**LEGAL ADVERTISEMENT
HISTORIC PRESERVATION BOARD
CITY OF PORTLAND
Public comments are taken at all meetings.**

HISTORIC PRESERVATION BOARD

HISTORIC PRESERVATION BOARD AGENDA

RE: June 15, 2016 **Public Hearing** – Review of amendments to approved site plan

Section / Elevation of proposed walls – as seen from driveway looking east

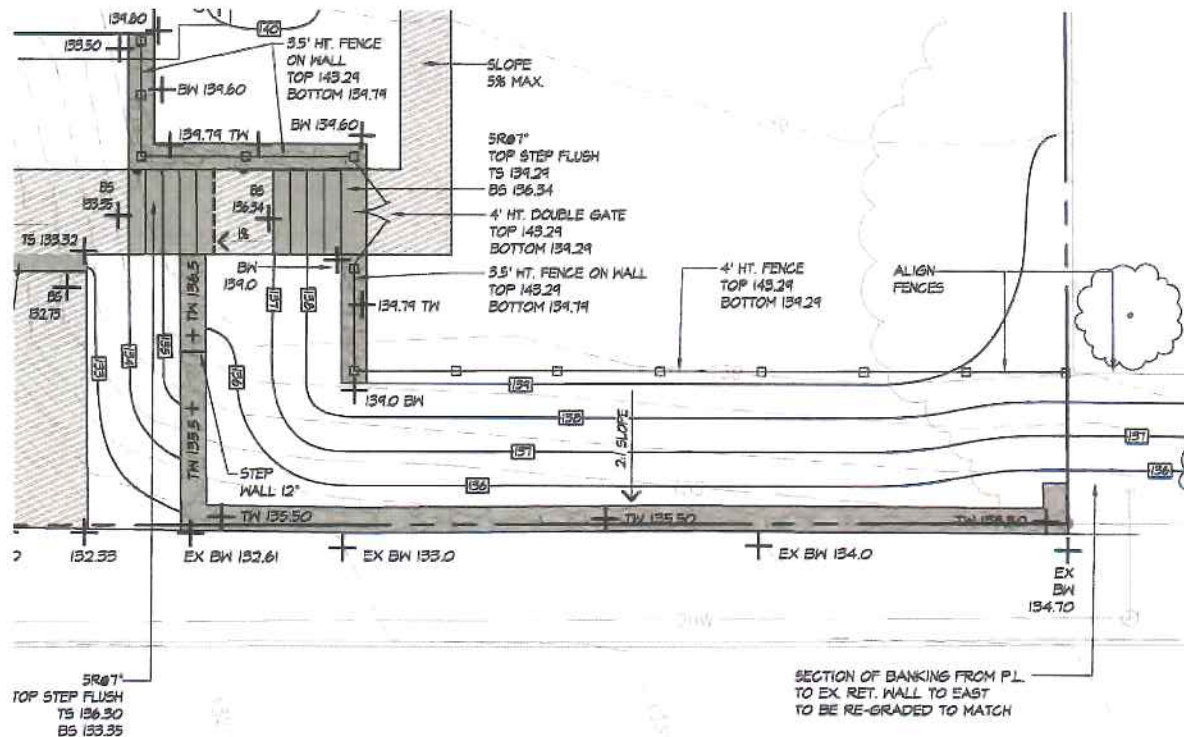
The landscape architect's plan, rendering and narrative present the proposed work clearly, and the character of the stonework is represented by the already completed walls. Staff notes that as in the original plan, the fence at the top of the bank would be aligned with the existing fence in the side yard of 5 Orchard Street approximately 9 to 10 feet from the sidewalk. The grade of the yard at the top of the bank would be no higher than in the original site plan, although that grade would be reached slightly closer to the sidewalk, thanks to the boost provided to the base of the bank by the proposed retaining wall at the sidewalk. The photo-simulation provided shows the bank heavily planted with ground cover, and larger shrubs that partially screen and soften view the fence from the street.

Staff agrees with the landscape architects that the proposed addition of a retaining wall at the back of the sidewalk is a feature that occurs with some frequency in the West End. Though clearly there are many examples of sloped banks without walls, the presence of walls at the lots on either side of the subject property establishes precedence and context. While it is somewhat uncommon for properties in the immediate neighborhood to have the degree of privacy within ten feet of the sidewalk that would be afforded by the proposed site plan, this aspect is not appreciably different from the nature of the originally approved plan, and it too is not without examples nearby.

Staff is slightly uncomfortable with the prospect of the yard grade (roughly 139') being reached somewhat closer to the sidewalk, but as shown in the sections in the narrative and in the original 2015 site plan, this should not greatly alter the character of the landscape. With the elimination of the low stone wall beneath the fence at the top of the bank (present in the January 2015 plan,) the total height of the fence above grade should be lower with the amended plan than originally depicted in 2015. Finally, a review of the proposed amendment by City planning staff found no significant change to grading and drainage as approved in the 2015 site plan.
